## Planning Commission Staff Report

**Project Type:** Sign Approval

**Description:** Clarkson Wilson Centre: A request for a free-standing sign to exceed six (6) feet in height, with an outline area to exceed fifty (50) square feet located on a 5.428 acre tract of land zoned "PC" Planned Commercial District, located at the intersection of Clarkson Road and Wilson Avenue.

Below is an image of the existing monument sign located at Clarkson Wilson Centre.

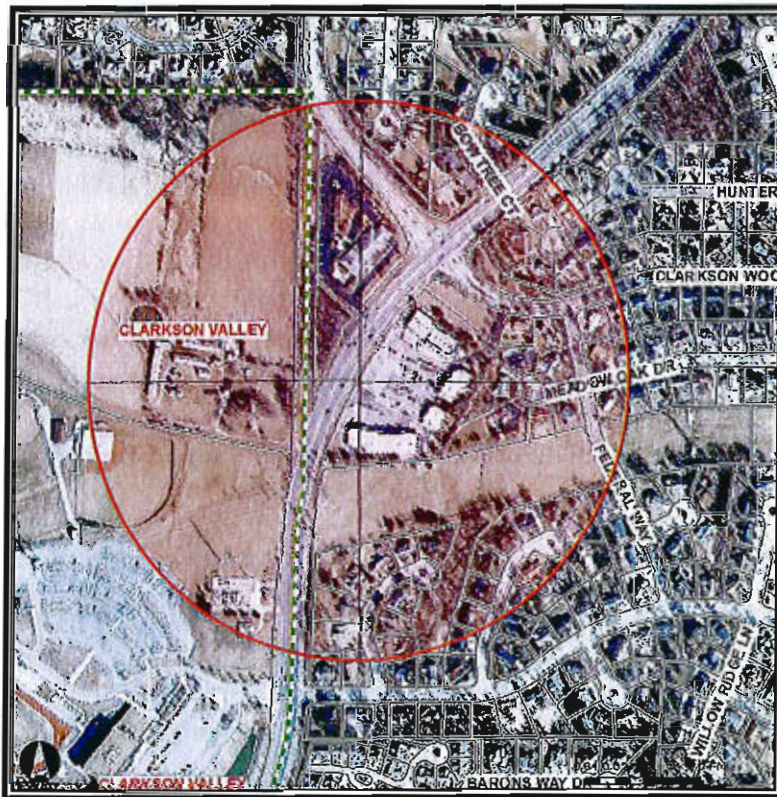
As stated in the applicant's letter to the Department, the site design of the development hinders the visibility of numerous tenant spaces. The applicant claims that the reduced visibility, coupled with an increasingly competitive retail environment, place the development at a disadvantage for tenant attraction and retention.

**SIGN ELEVATION: 3/8" = 1'-0" (100 SF SIGN FACE AREA)**

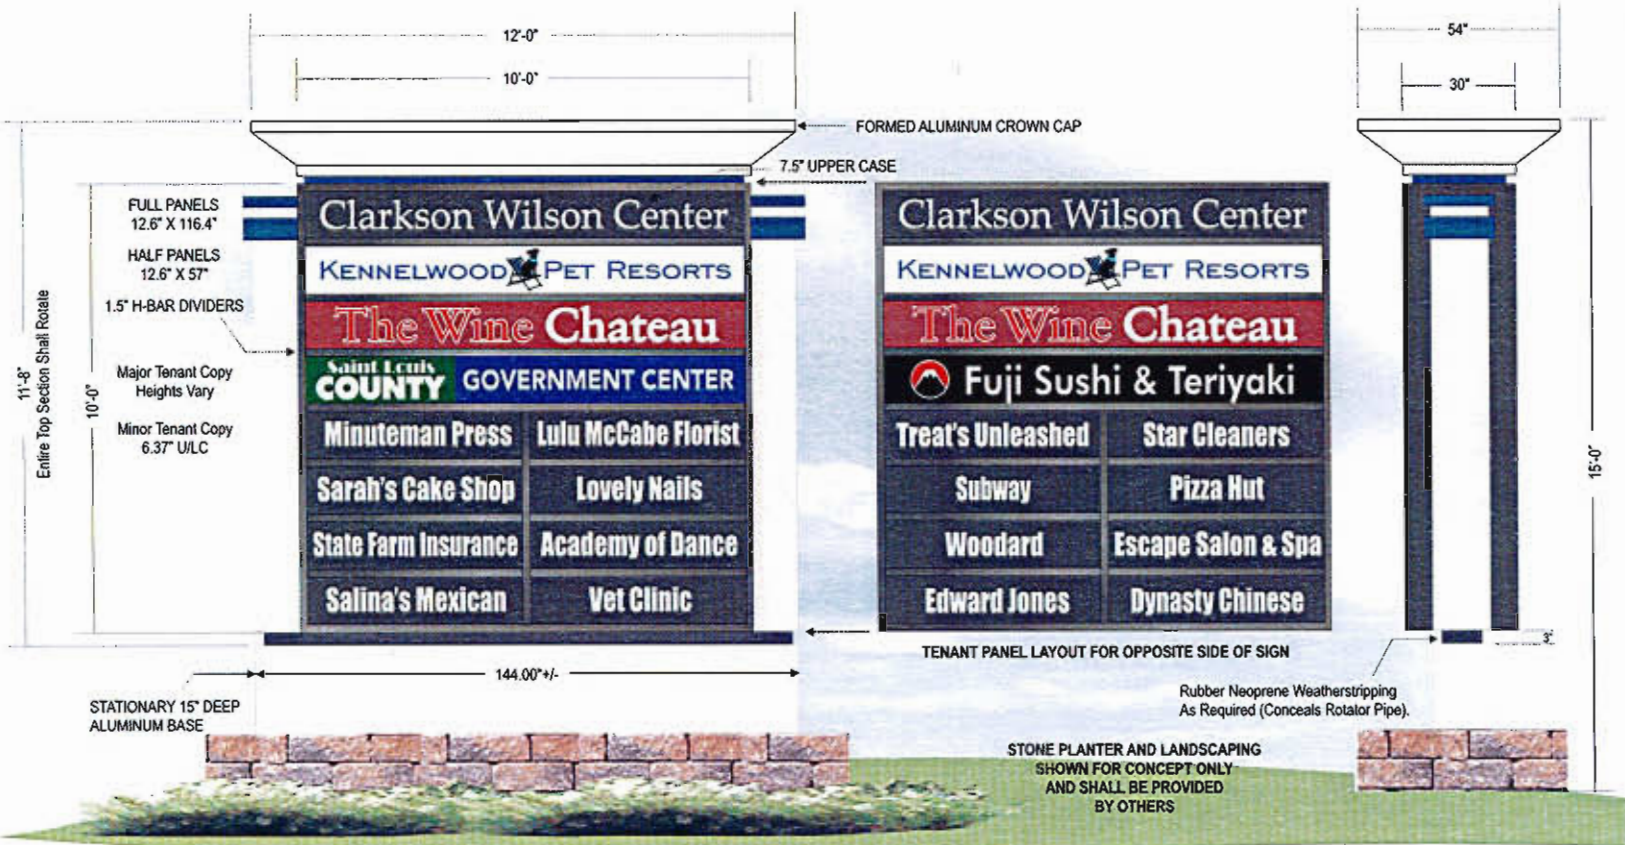
The applicant is requesting a sign height of 11 feet 11 inches. The height is measured from the average grade of Clarkson Road, as permitted in the Zoning Ordinance.

The application is requesting an outline area of 100 square feet.

Staff has worked with the applicant to reduce the size of the sign from the original intent by the developer. Based on discussions and meetings with Staff, the developer has worked with their sign company to develop a sign they believe provides the necessary visibility for the tenants of the development. The size of the tenant panels are designed based on the travel conditions along Clarkson Road (e.g. speed limit and roadway curvature). There are currently 20 tenants in the development. Based on the

outline area limitations and the number of tenants in the development, sign design that would allow for each tenant to have signage along Clarkson Road was not possible. In order to account for this limitation, the applicant is proposing a sign that is able to be manually rotated so that tenant signage can be oriented to both directions of travelers along Clarkson Road at different times. Based on discussions with the developer, rotation of the sign could be expected to occur 1-2 times per week.

The sign is proposed to be a neutral tone color to blend in with the existing shopping center constructed on the site. The sign, similar to the building, will contain a teal accent color. Additionally, the sign includes a stone landscaping retaining wall. Staff has discussed the potential of removing the existing cap on the sign to reduce the height of the sign. While the developer did not dismiss the idea, they believe that the cap provides an architectural element to the sign that increases the attractiveness of the sign. The sign proposes to utilize backlight panels in accordance with the City of Chesterfield Lighting Ordinance.

The submittal is in compliance with all applicable City of Chesterfield ordinances. The proposed increase in sign size and outline area seeks to allow for tenant signage to be located along the frontage of Clarkson Road to address the limited tenant visibility and increase tenant identification within the shopping center. While the sign is located on a state highway, the development also abuts several residential uses. The Zoning Ordinance allows for sign height to be measured from the average grade of the adjacent street, as is being utilized in this request (the height from the finished grade of the sign is 15 feet). Additionally, the impact of the sign on the residential area to the east of the site has not been addressed.

The Department of Planning and Public Works recommends that the increase in sign height and size not be approved. Under the sign regulations, a sign 9' 1" can be constructed on the site because of the grade differential between the site and the street. While the additional size will not increase options for providing tenant signage, the flexibility to increase the size of the existing size provides a mechanism for the property owner to increase the branding and marketing of the site as Clarkson Wilson Centre.

Sign/Site Overview  
30' Sight Triangle  
Observed.

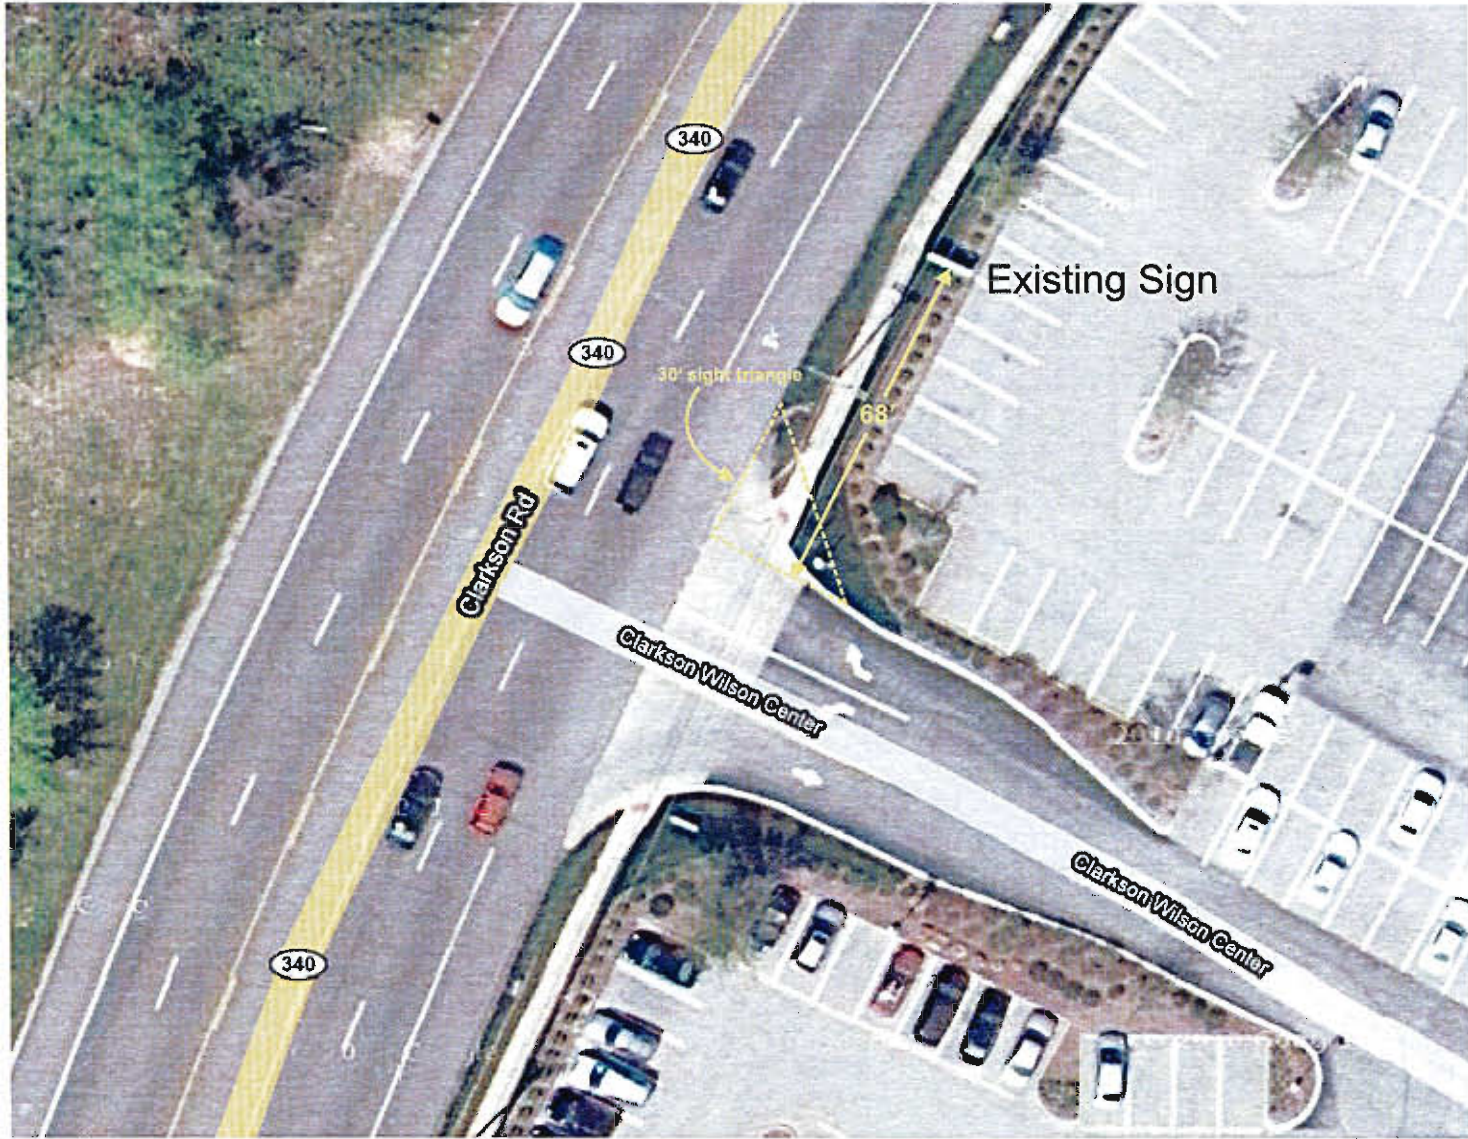
The sign is proposed to be located in the same location as the existing sign with a protrusion of the new sign into the parking lot. The increase in the width of the sign will require the removal of two parking spaces. Staff has reviewed the changes to the parking provided and verified that the center will still meet minimum parking requirements. If the sign size is approved, an Amended Site Development Plan will be required to be submitted for a complete review by the Department of Planning and Public Works.
